Z-48  
(2014)

ZONING PLAN FOR:  
DAVID PEARSON COMMUNITIES  
PROPERTY IS LOCATED IN LAND LOT 629 & 630  
IN THE 16TH DISTRICT, 2ND SECTION  
COBB COUNTY, GEORGIA  
SCALE: 1" = 50'  
DATE: APRIL 21, 2014  
REVISED: JULY 24, 2014

**PETITION NO:** Z-48  
**HEARING DATE (PC):** 07-01-14  
**HEARING DATE (BOC):** 07-15-14  
**PRESENT ZONING:** LRO  
**PROPOSED ZONING:** FST

**ZONING COMMENTS:**

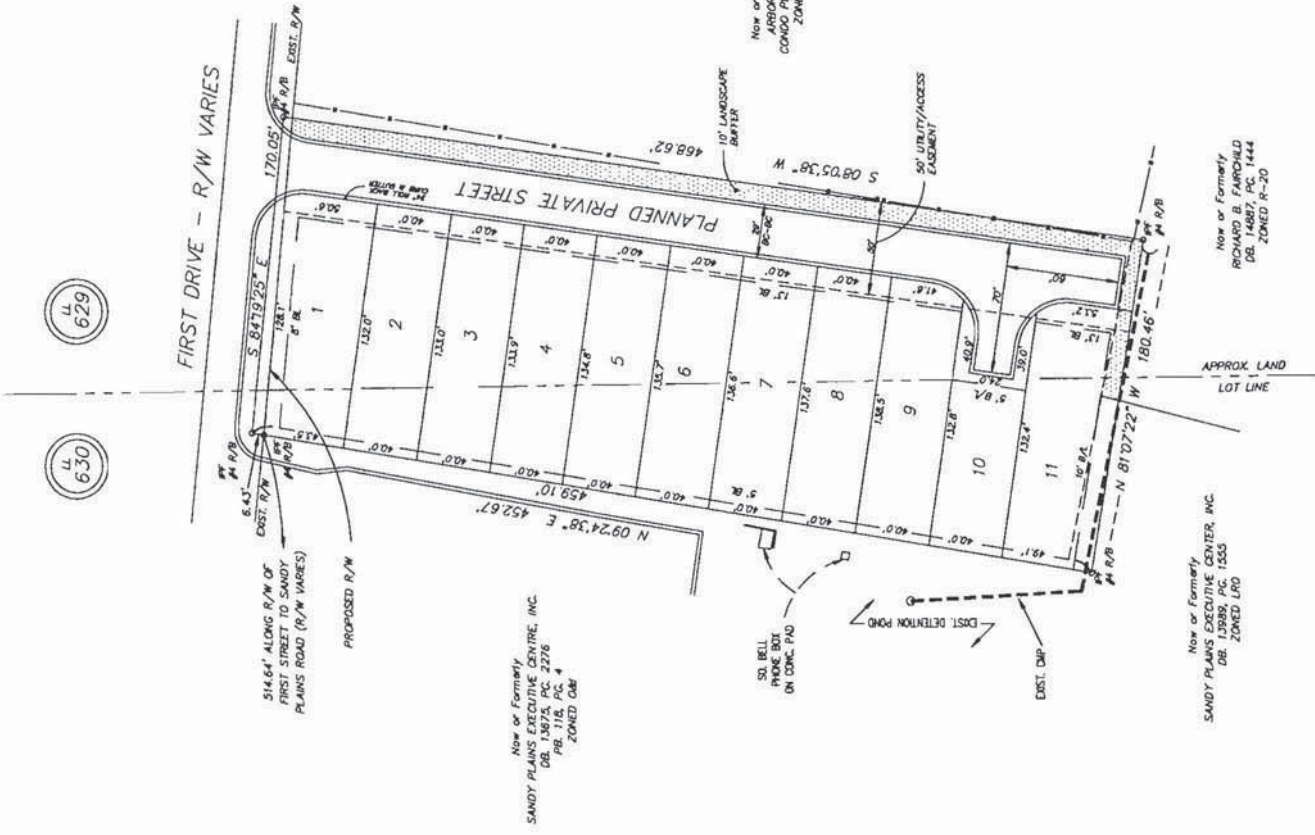
The site plan indicates a private street is planned and the applicant requests that the setbacks for the development be geared toward the private street, instead of First Drive. This will require granting a waiver of the front setback along the private street from 25 feet to 13 feet; waiving the rear setback abutting the eastern property line from 35 feet to 20 feet.

When projects contemplate less than 20 foot separation between units, guest parking shall be provided or the streets shall be labeled as a fire lane.

Additional Comments: Master meter to be set at public ROW

Additional Sewer to be private in private street  
Comments:

- Provide comprehensive hydrology/stormwater controls to include development of out parcels.
- Submit all proposed site improvements to Plan Review.
- Any **spring activity** uncovered must be addressed by a qualified geotechnical engineer (PE).
- Structural fill \_\_\_\_\_ must be placed under the direction of a qualified registered Georgia geotechnical engineer (PE).
- Existing facility.
- Project must comply with the Water Quality requirements of the CWA-NPDES-NPS Permit and County Water Quality Ordinance.
- Water Quality/Quantity contributions of the existing lake/pond on site must be continued as baseline conditions into proposed project.
- Calculate and provide % impervious of project site.
- Revisit design; reduce pavement area to reduce runoff and pollution.

- No Stormwater controls shown \_\_\_\_\_
- Copy of survey is not current – Additional comments may be forthcoming when current site conditions are exposed.
- No site improvements showing on exhibit.

1. This site is located on First Drive between Sandy Plains Executive Center to the west and the Arbor Oaks Suburban Condominium development to the east. The entire site drains to the east through the Arbor Oaks development. With the proposed layout a drainage easement will be required along the rear of all the lots to adequately control runoff from the site. Since it appears that underground detention will be utilized under the private street, it may be necessary to relocate the street to the low-side of the site, adjacent to Arbor Oaks, to adequately control site runoff.

2. The detention pond for the adjacent Sandy Plains Executive Center discharges through an existing pipe along the southern boundary of this site. An adequate drainage easement must be provided for this conveyance.

3. Since private streets are proposed all stormwater management within the development including the detention facility will be privately maintained in perpetuity by the HOA.

First Drive is classified as a local and according to the available information the existing right-of-way does not meet the minimum requirements for this classification.

Recommend applicant consider entering into a development agreement pursuant to O.C.G.A. 36-71-13 for dedication of the following system improvements to mitigate traffic concerns: a) donation of right-of-way on the south side of First Drive, a minimum of 25' from the roadway centerline.

Recommend curb, gutter, and sidewalk along the First Drive frontage.

Recommend private streets be constructed to the Cobb County Standard Specifications.

Based on the above analysis, Staff recommends DELETING the request to RA-5 subject to the following conditions:

- Site plan to meet all RA-5 requirements;
- Detached, single-family houses only;
- Fire Department comments and recommendations;
- Water and Sewer Division comments and recommendations;
- Stormwater Management Division comments and recommendations;
- Department of Transportation comments and recommendations; and
- Owner/developer to enter into a Development Agreement pursuant to O.C.G.A. §36-71-13 for dedication of system improvements to mitigate traffic concerns.
